# Notice of Allowability

10/609,096

KUHN ET AL.

5,154,021

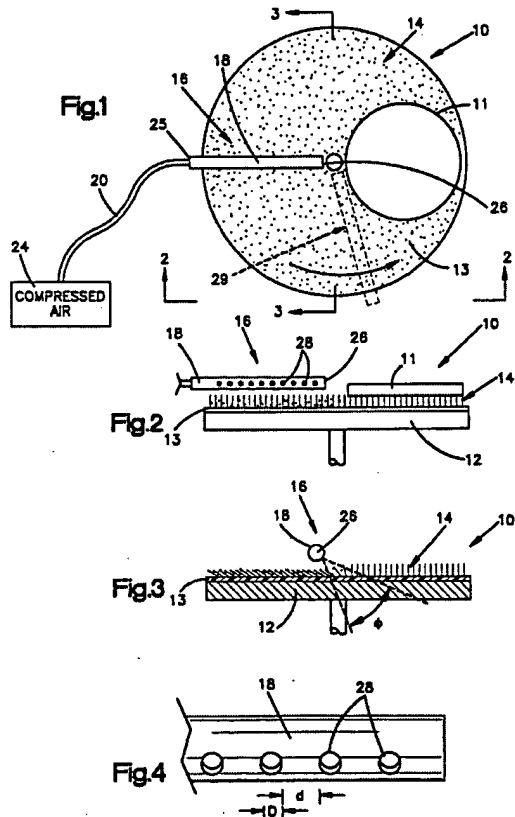
As illustrated in FIGS. 2 and 4, a plurality of perforations, as indicated at 28, are formed in the wall of the pipe 18. Each of the perforations 28 has a diameter  $D$ . The perforations are preferably equally spaced at  $d$  intervals along the length of the pipe 18. The distance  $d$  between the edges of the perforations and the diameter of the perforations is preferably equal. It has been determined that for the above-described process the diameter  $D$  and distance  $d$  should be approximately  $\frac{1}{8}$ ". Alternatively, it is also within the scope of the invention to provide a thin slot extending along the length of the pipe in lieu of the perforations.

The air supply 24 is conventional in design and provides compressed air (or other appropriate gas or liquid) through the flexible tube 20 to the inlet port 25 of the pipe 18. The air fills the pipe and is forced through the perforations 28 in a substantially uniform stream. The perforations 28 direct the air downwardly against the fibers on the polishing pad at an angle  $\phi$  (FIG. 3), which angle is approximately  $45^\circ$  in the direction of rotation of the platen.

However, the prior art of record fails to provide or suggest the specific limitations of “at least one nozzle ... said polishing pad” in the combination as claimed in claim 1, “supplying a high pressure fluid ... said polishing pad” in the combination as claimed in claim 25.

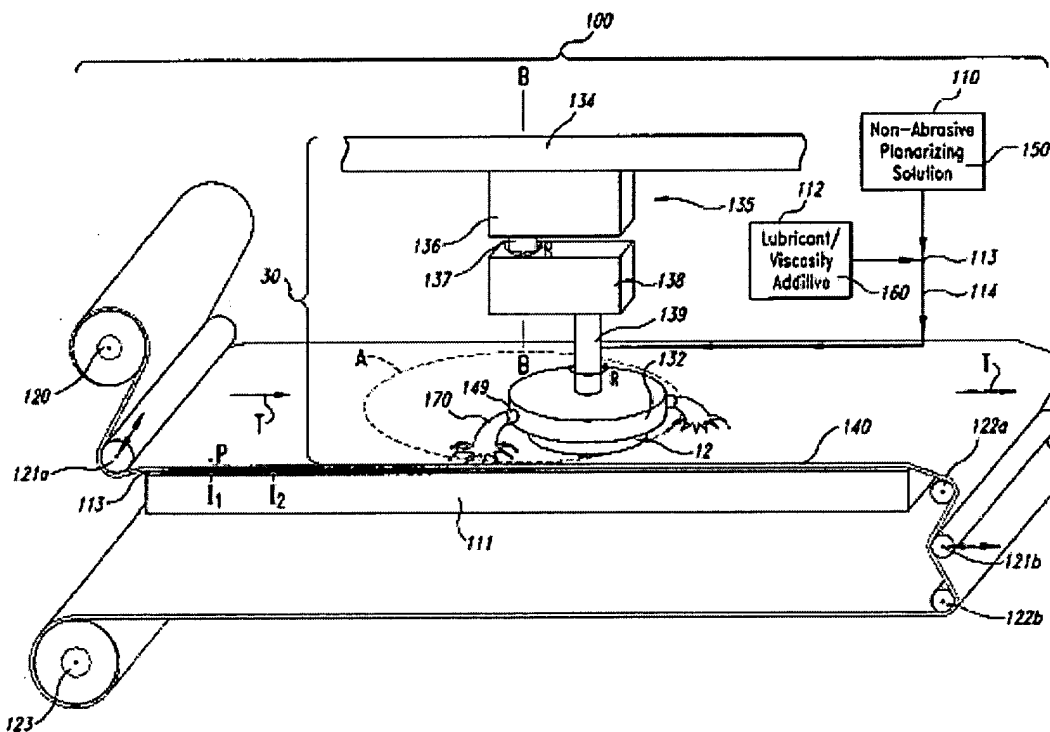
Regarding to claims 44 and 50, Sabde'6,306,012 discloses methods and apparatus for planarizing substrates assemblies. The apparatus includes a polishing head 132 having at least one nozzle 149 coupled thereon to provide a lubricating planarizing solution 170 onto the fixed abrasive polishing pad.

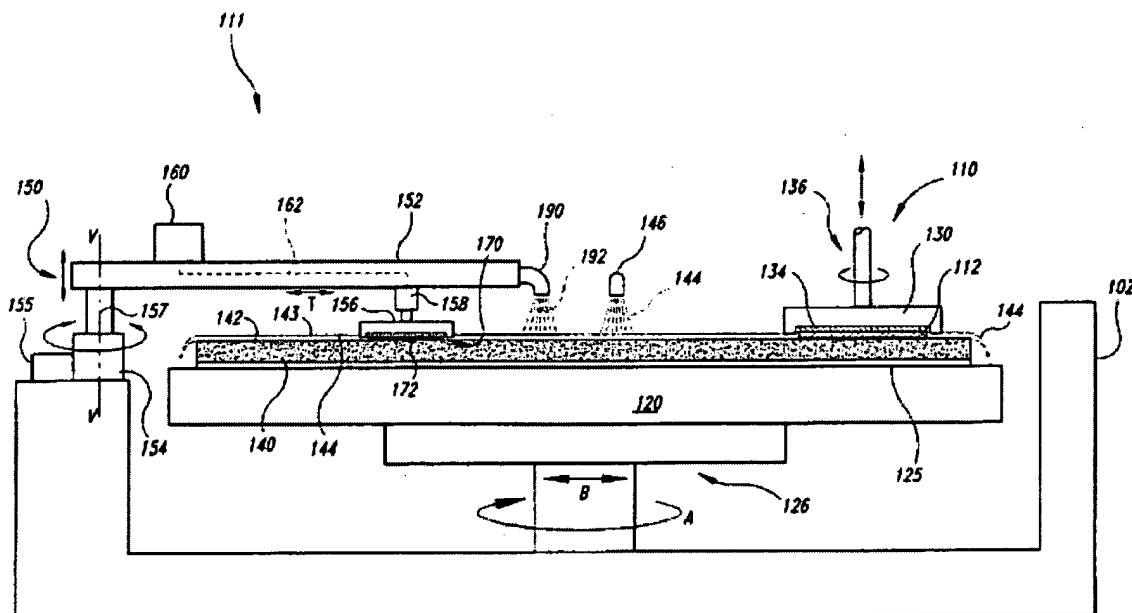
With reference to Figure 3, Southwick '5,782,675 discloses an apparatus 150 for conditioning fixed-abrasive polishing pad. Apparatus 150 includes an arcuate shaped

nozzle 190 having a circular opening to inject conditioning fluid 192 into the polishing pad. Said nozzle 190 coupled to arm 152 which carries a conditioning head 156.

However, the prior art of record fails to provide or suggest the specific limitations of “at least one nozzle, having arcuate shaped opening, ... said polishing pad” in the combination as claimed in claim 44, and “supplying a high pressure pad conditioning fluid ... said polishing pad” in the combination as claimed in claim 50.
